# UNITED STATES PATENT AND TRADEMARK OFFICE

APPLICATION NO.	FILING DATE	FIRST NAMED INVENTOR	ATTORNEY DOCKET NO.	CONFIRMATION NO.
10/026,941	12/27/2001	Jung Taeck Yer	049128-5029	7312
9629	7590	03/30/2006	EXAMINER	
MORGAN LEWIS & BOCKIUS LLP 1111 PENNSYLVANIA AVENUE NW WASHINGTON, DC 20004			MAI, ANH T	
			ART UNIT	PAPER NUMBER
			2832	
DATE MAILED: 03/30/2006

<b>Office Action Summary</b>	<b>Application No.</b> 10/026,941	<b>Applicant(s)</b> YER ET AL.	
	<b>Examiner</b> Anh T. Mai	<b>Art Unit</b> 2832

**FIG. 2*****Claim Rejections - 35 USC § 103***

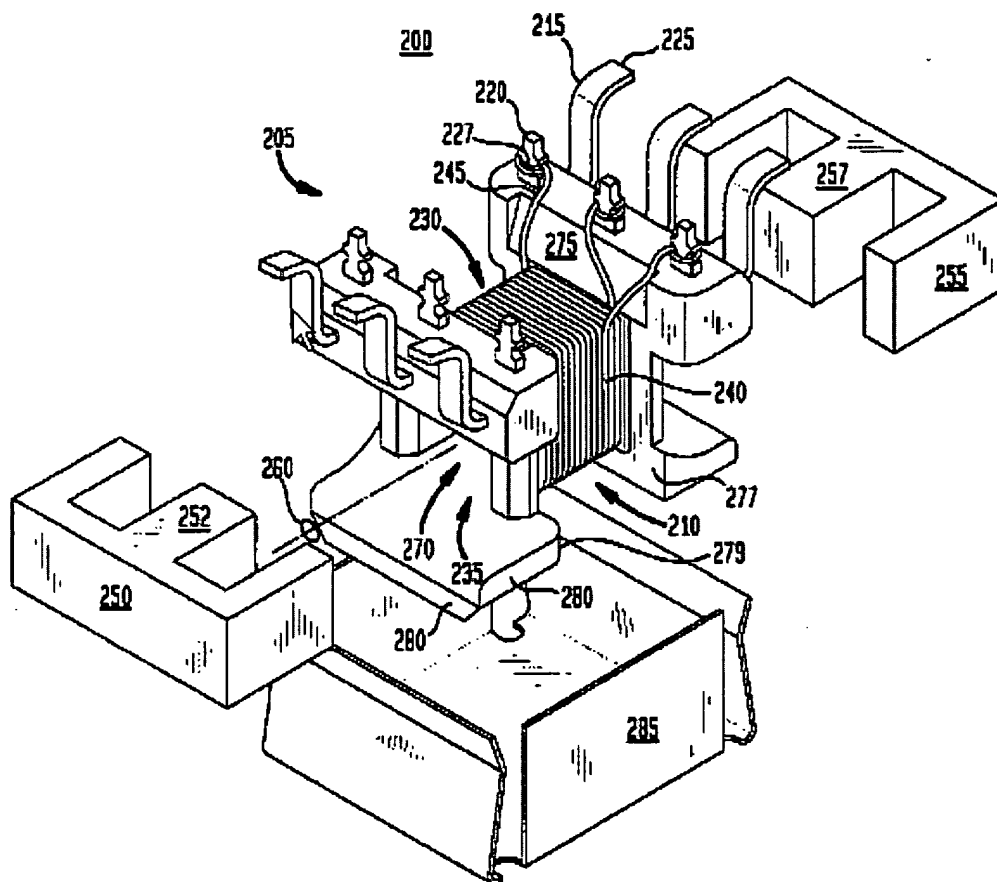
2. Claim 10 is rejected under 35 U.S.C. 102(b) as being anticipated by Banzi Jr. et al. [6326874].

Banzi discloses:

- a bobbin wound with a coil 240 and two E-shaped cores 250, 255 introduced into the bobbin;
- the bobbin provided with a coil winding part having no protrusion member so as to exclude an interference caused by the protrusion member;
- a pair of lead pins 220 each extending from opposing ends of the bobbin along opposing direction parallel to the length of the bobbin;
- the coil is continuously wound from one side of the coil winding part to another side thereof and connected to two lead pins at primary side and a secondary side without using a return wire;

- the core having centers 252, 257 passing through a center of the bobbin and sidewall portions surrounding sides of the bobbin as shown in figure 2.

**FIG. 6**

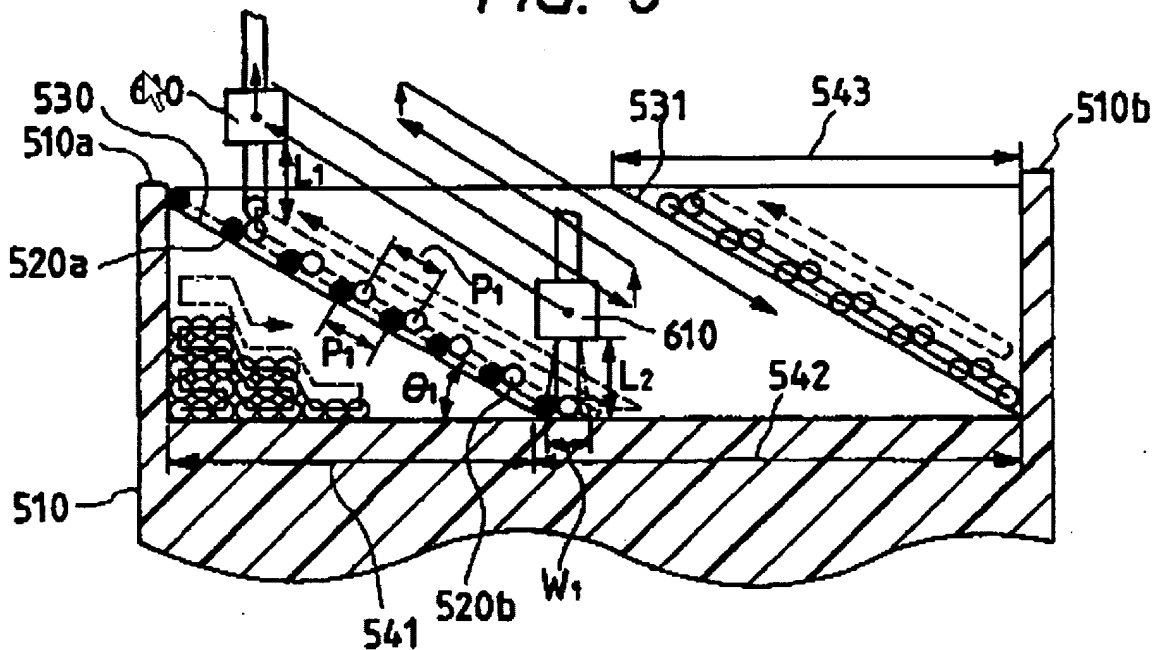
3. Claims 11-12, 14-16 are rejected under 35 U.S.C. 103(a) as being unpatentable over Banzi, Jr. et al. [6329874] in view of Kawano et al.

Banzi discloses the invention as claimed as cited above except for the coil continuously wound from one side of the coil winding part to another side on a zigzag basis in an oblique direction. Kawano discloses the coil continuously wound from one side of the coil winding part 510a to the other side 510b on a zigzag basis in an oblique direction [figure 6, col 11, lines 21-30]. With respect to claim 14, Kawano's winding having winding block wherein the coil is continuously wound from a lower portion to an upper portion such that the coil blocks have a number of winding [see left bottom corner of figure 6]. At the time of the invention, it would have been obvious to a person of ordinary skill in the art to wind the coil continuously in zigzag basis from one side to the other as taught by Kawano to the coil as disclosed by Banzi. The motivation would have been to eliminate undesirable excursion of wire rod therefore it becomes possible to prevent deterioration of insulation quality due to winding collapse [col 11, lines 38-44]. Therefore, it would have been obvious to combine Kawano with Banzi.

With respect to claim 12, the coil is continuously wound from one side of the coil winding part to the other side.

With respect to claim 15, the coil is wound from lower portion to upper portion as shown in fig 6.
